**Dartbrook Mine  
Modification to DA 231-7-2000**

## 2. RESPONSES TO IPC REQUEST FOR INFORMATION

**Figure 1: Newcastle Historical Thermal Price**

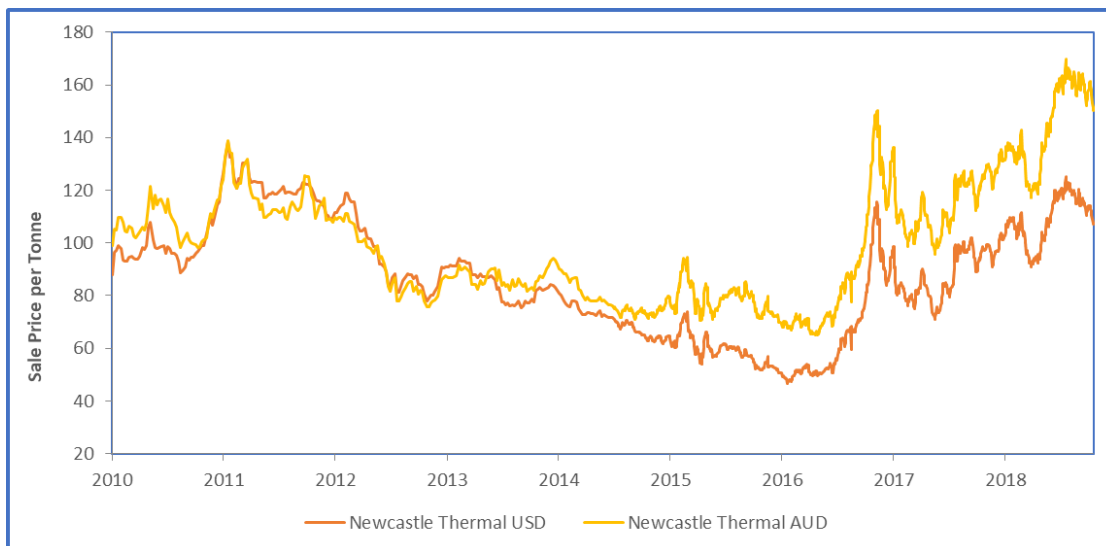
For example, in calendar year 2018, the AUD achieved price for the Newcastle 6,000 kcal/kg benchmark specification ranged<sup>1</sup> from around AUD 115 to 180 per tonne, averaging AUD 145 per tonne. The Modification contemplates producing a 5,500 kcal/kg energy content that has historically traded at a discount of 15-30%<sup>1</sup> of the Newcastle 6,000 kcal/kg benchmark. Whilst this produces a large implied range of prices for coal produced for the Modification, it can be seen that the assumed price of AUD 95 is not an unreasonable view given recent and historical observed pricing.

To further note this point, the present USD:AUD exchange rate is 0.6878 ([www.rba.com.au](http://www.rba.com.au) as of 21 May 2019) which, all other things being equal, would produce a 12% higher AUD achieved price against the assumption used within the MOD7 EA.
